Swift No. 1 Hydroelectric Project FERC Project No. P-2111

Application for License Amendment

**Volume I of V
Initial Statement and Exhibits A, C, D and G**

**APPLICATION FOR NON-CAPACITY AMENDMENT OF LICENSE
FOR A MAJOR PROJECT - EXISTING DAM**

Figure 1. Lewis River Basin and major tributaries to Swift Reservoir.

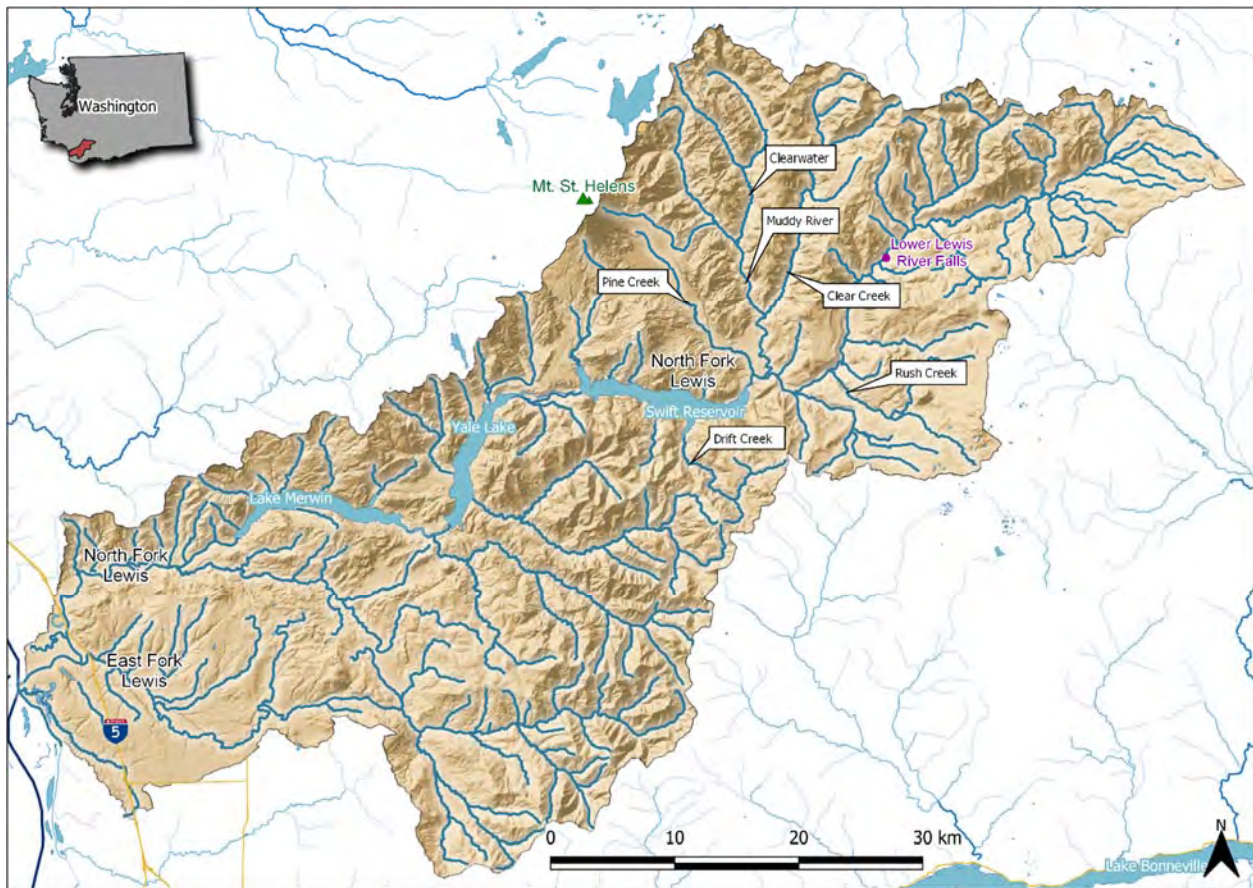
WDFW	11	Please include a legend in Figure 1. It is unclear if the red dots are the upper extent for fish passage or used to identify the stream/river.	Figure 1 of the Strategic Plan has been revised.
WDFW	12	The Strategic Plan identifies previous restoration work in the Lewis River watershed by sponsor. Please identify the location in the watershed the sponsors completed restoration activities. Since NMFS designated that restoration efforts focus on stream reaches above Swift reservoir, limiting the list to projects above Swift reservoir would be more appropriate.	To the extent possible, prior restoration projects completed in the upper watershed have been identified/summarized - sources of information include NOAA's PNW Salmon Habitat Project Tracking Database.
WDFW	13	It currently inappropriate to state “...it is the intent of the Utilities, Services, and Aquatic Coordination Committee (ACC) to develop a framework for an [Habitat Restoration Plan (HRP)] that will include reach and site-specific recommendations for restoration and enhancement measures.” WDFW believes that the Utilities have not confirmed with the ACC that it supports development of a framework for HRP or the content of the HRP.	Text has been revised as follows: "As described in Section 2.0 of this Plan, it is the intent of the Utilities and Services, and Aquatic Coordination Committee (ACC) to develop a framework for an HRP that will include reach and site-specific recommendations for restoration and enhancement measures."

- Please include a legend in Figure 1. It is unclear if the red dots are the upper extent for fish passage or used to identify the stream/river.
- The Strategic Plan identifies previous restoration work in the Lewis River watershed by sponsor. Please identify the location in the watershed the sponsors completed restoration activities. Since NMFS designated that restoration efforts focus on stream reaches above Swift reservoir, limiting the list to projects above Swift reservoir would be more appropriate.

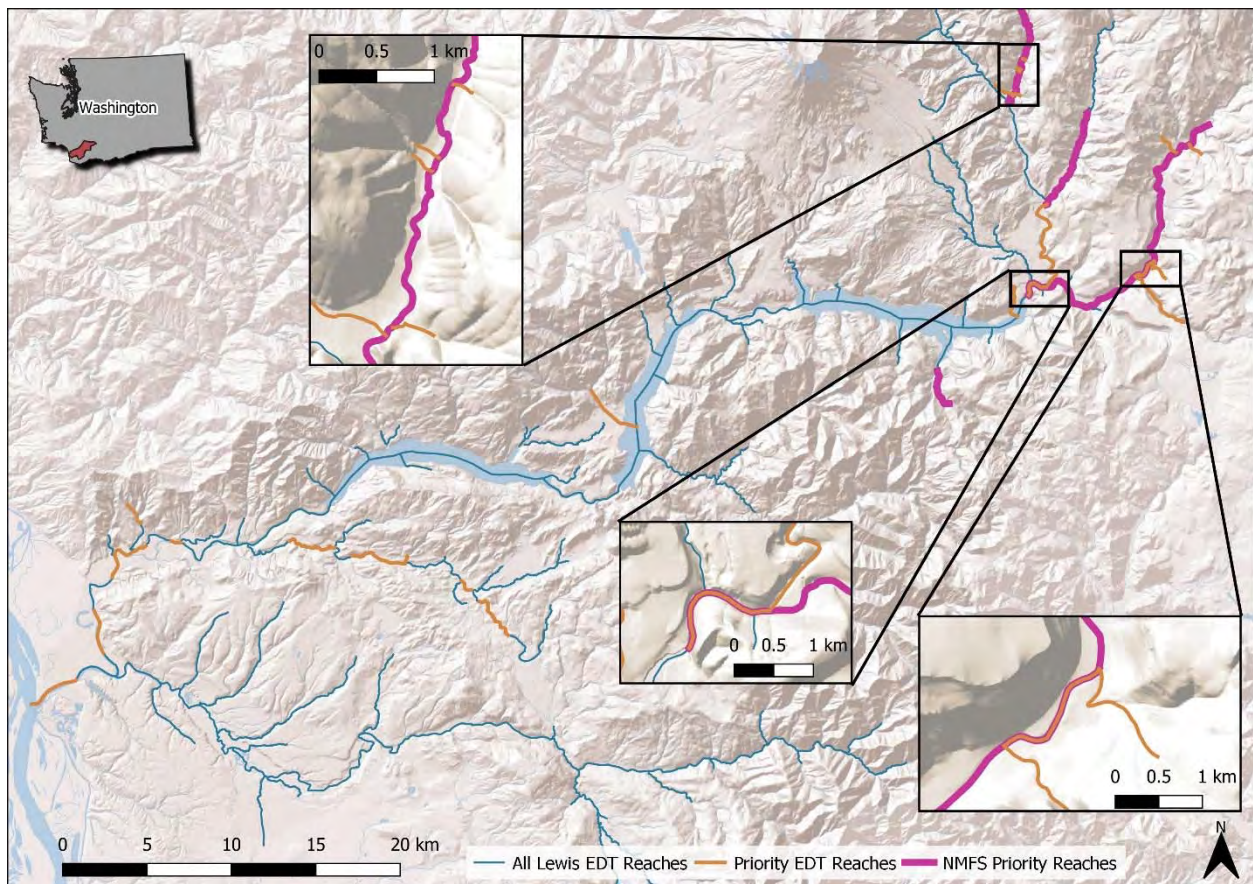
- Figure 4. and other sections within the Strategic Plan propose to prioritize protection and preservation above restoration of watershed processes and habitat features. This is contrary to the goals and objectives outlined in the In Lieu Letter and in Settlement Agreement section 7.6.3. Prioritizing protection and preservation projects before restoring habitat functions and features is not likely to meet the In Lieu Letter or Settlement Agreement goals/objectives. From WDFW’s perspective, not only should the ACC collectively determine the goals of the Merwin In Lieu Program and HRP, it should also collectively determine the prioritization of protection and preservation, restoring watershed processes, and restoring habitat features.
